ADDENDUM NO. 1:

Date: February 20, 2017

Project: The EDGE Business Resource Center

Architect: Ward Scott Architecture, Inc.

A301

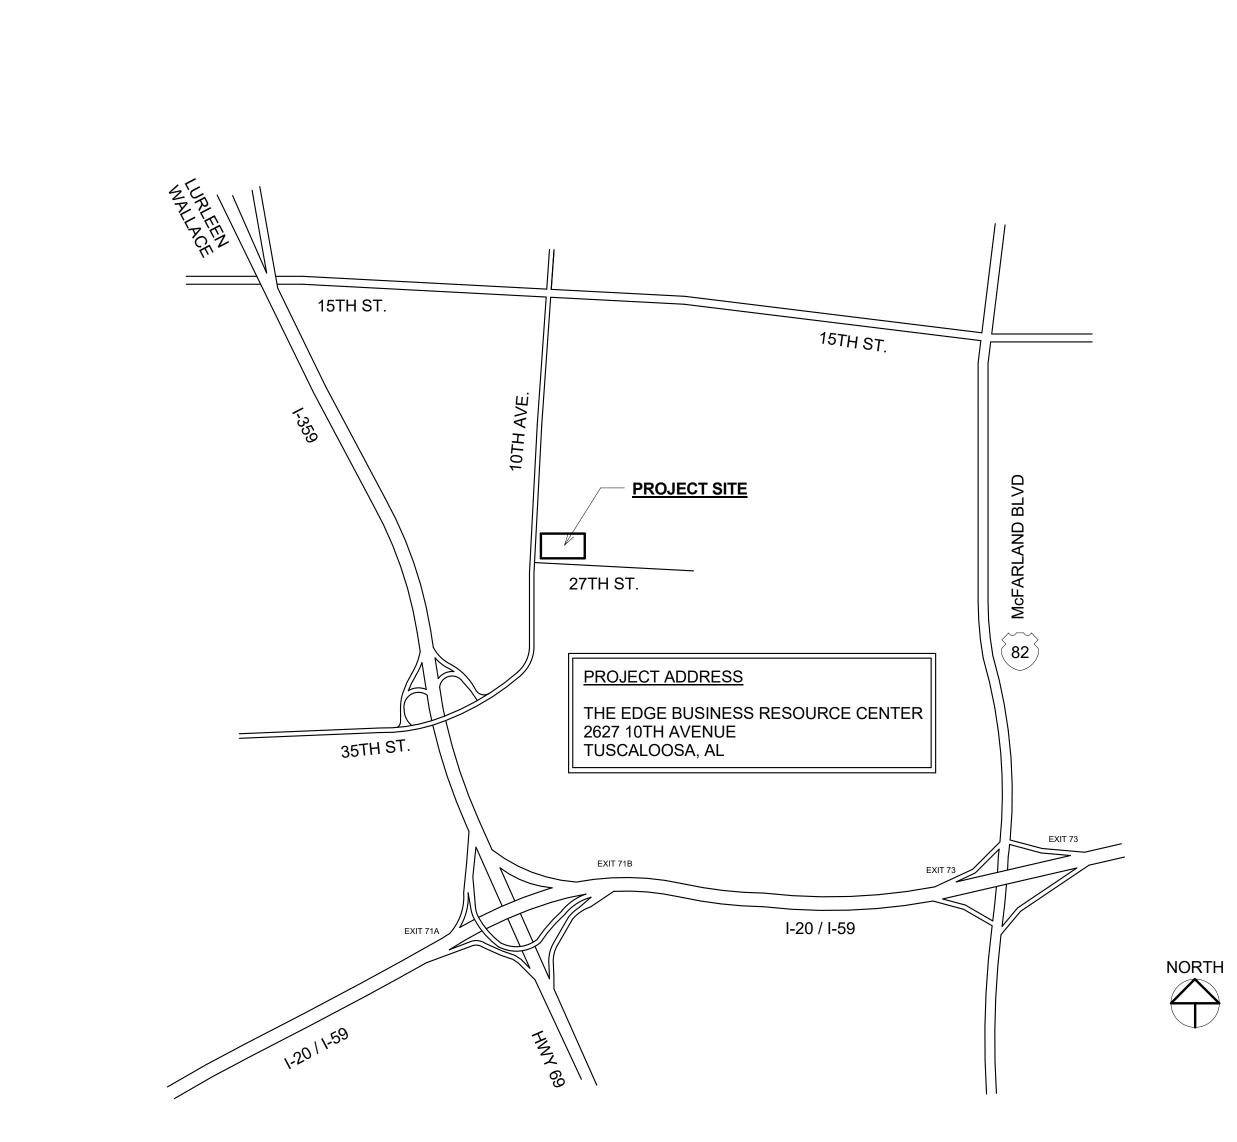
- 6. Refer to #2 Building Section 2 on Sheet A301. Delete the wall partition and modify the ceiling at the deleted office locations. The wall partition located at the north end of room #153 Open Studio is shown at 9'-0" AFF.

A001

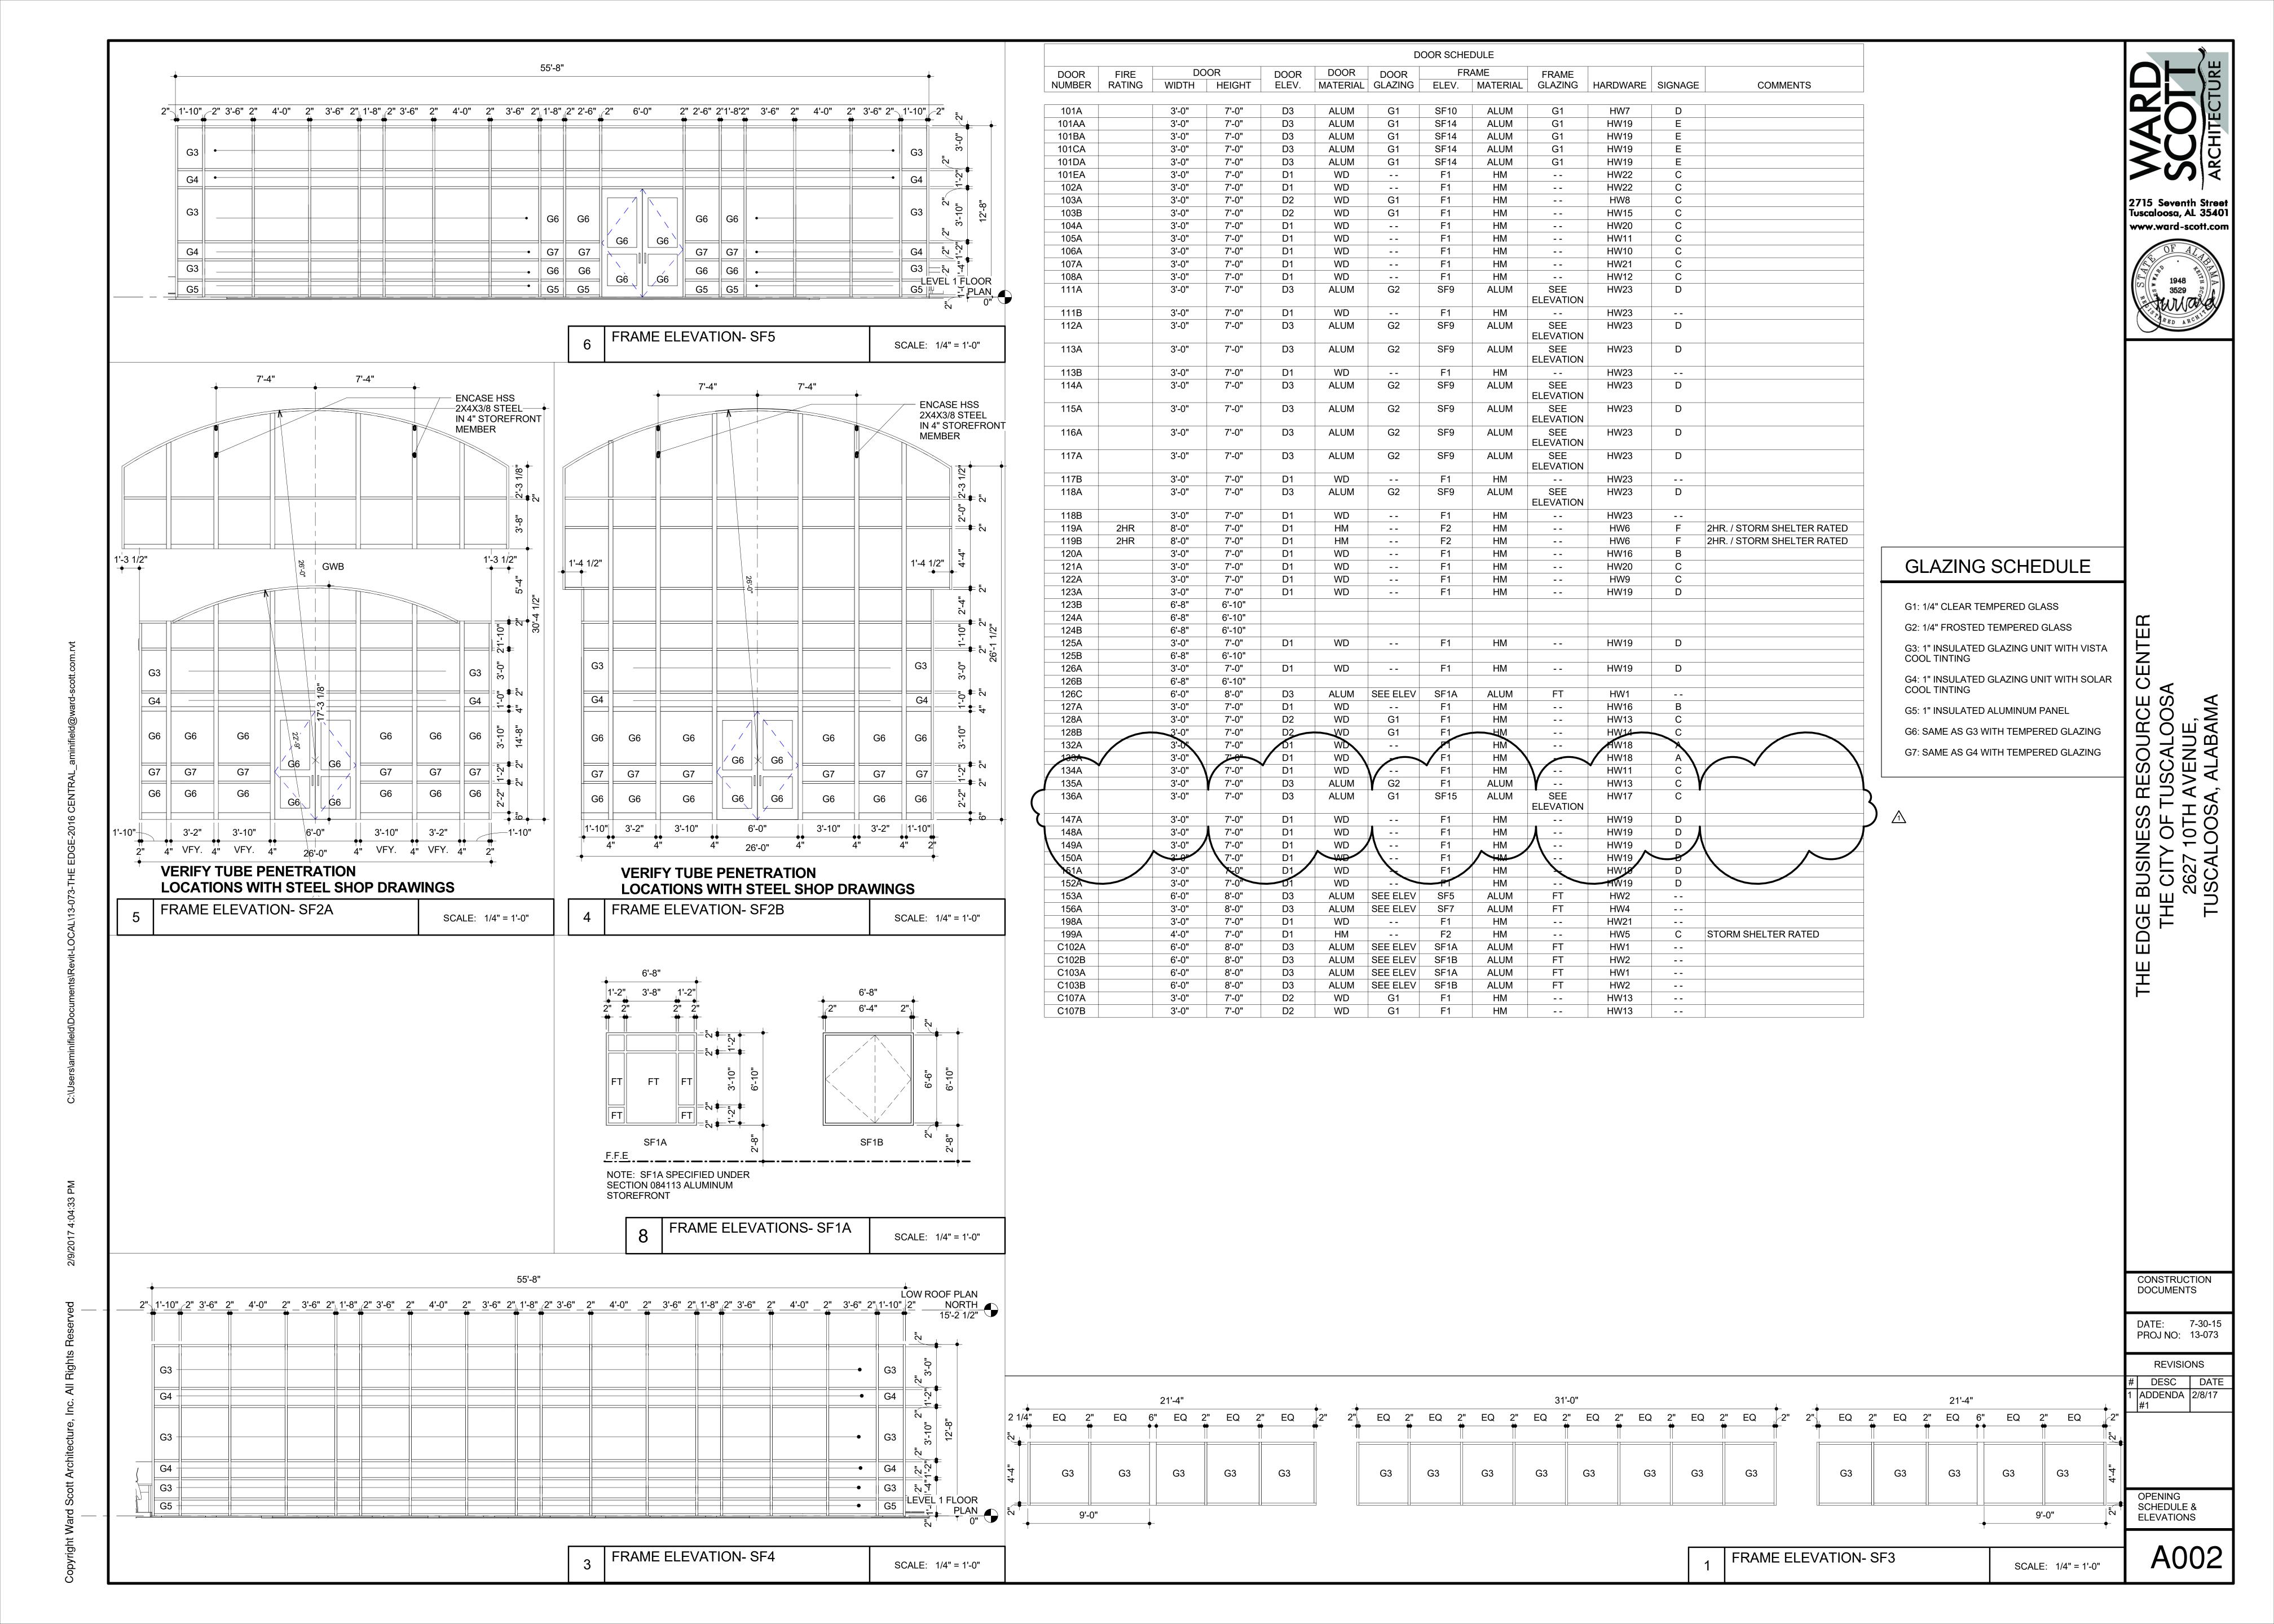
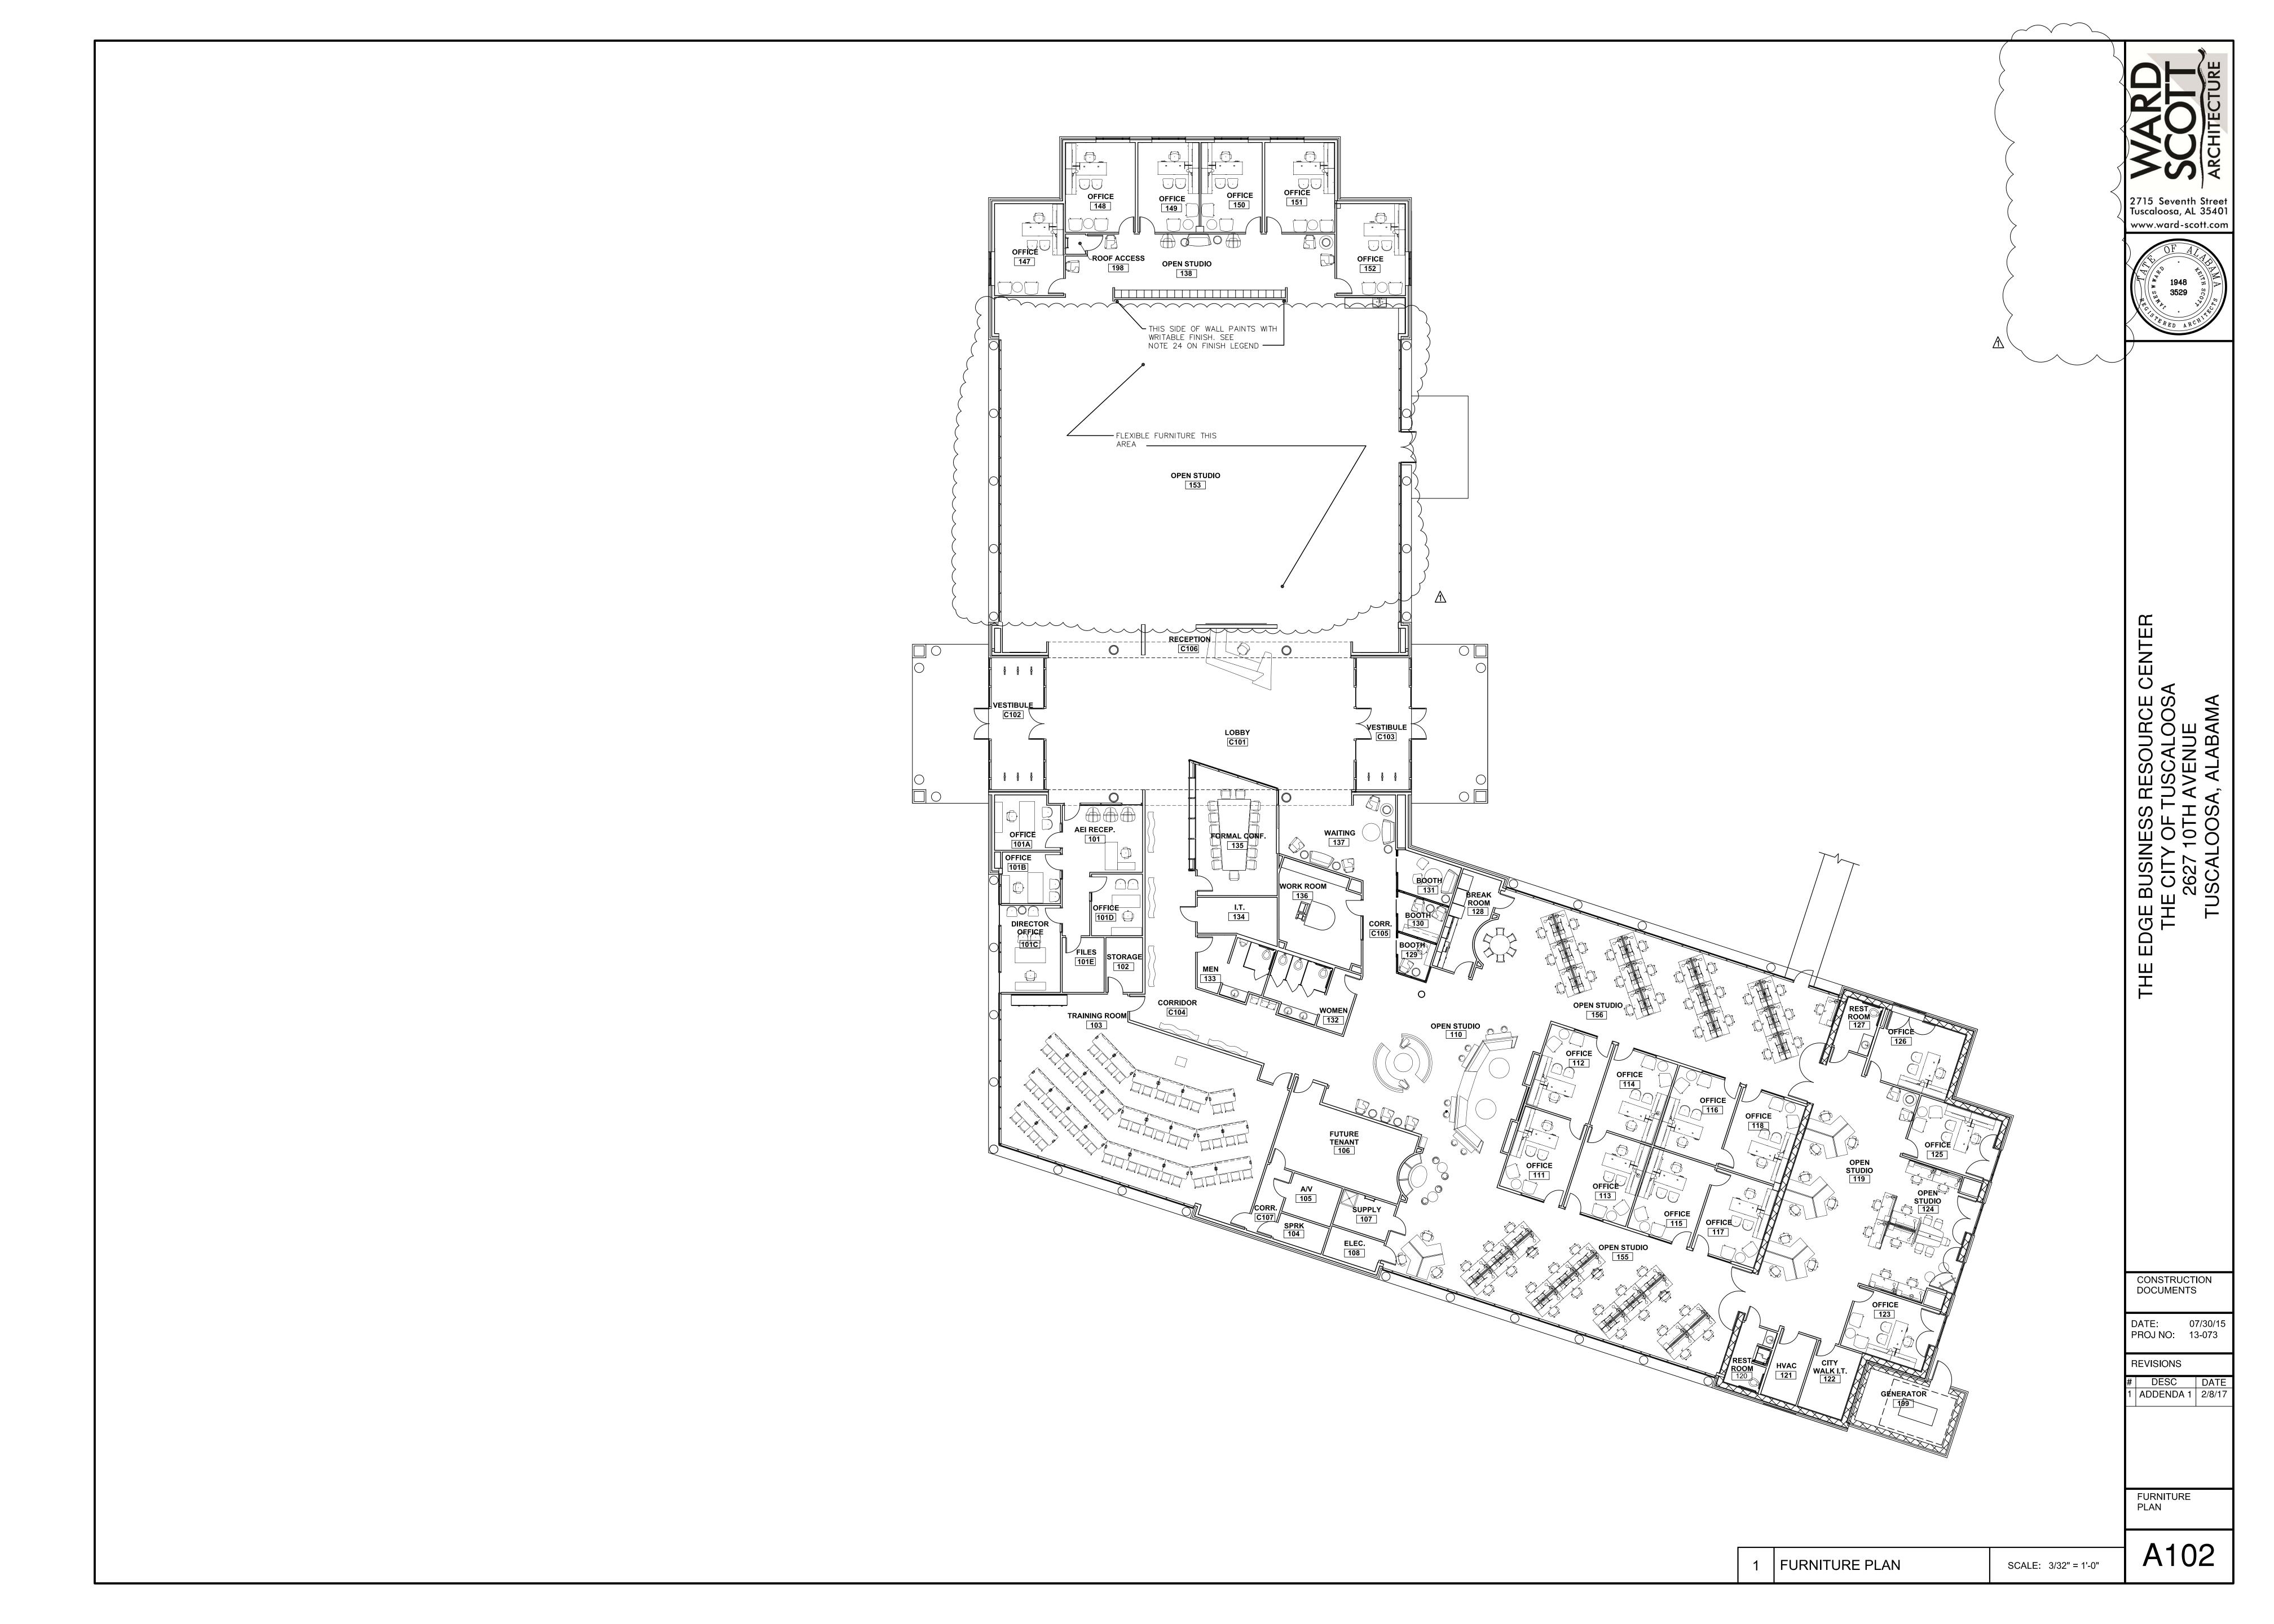
- B. Drawings Revision #1 dated February 7, 2017 Attached Drawings:
 - 1. Refer to Cover Sheet G101. Modify the City Project Number to A16-1320.
 - 2. <u>Refer to Room Finish Schedule Sheet A001.</u> Delete the following rooms and associated room finishes from the Schedule: Open Studio #157, Open Studio #158, Office #139, Office #140, Office #141, Office #142, Office #143, Office #144, Office #145 and Office #146. Modify the finishes for Open Studio #153 as shown on the revised room finish schedule. Add marker paint, #XXXX at Open Studio #153 north wall.
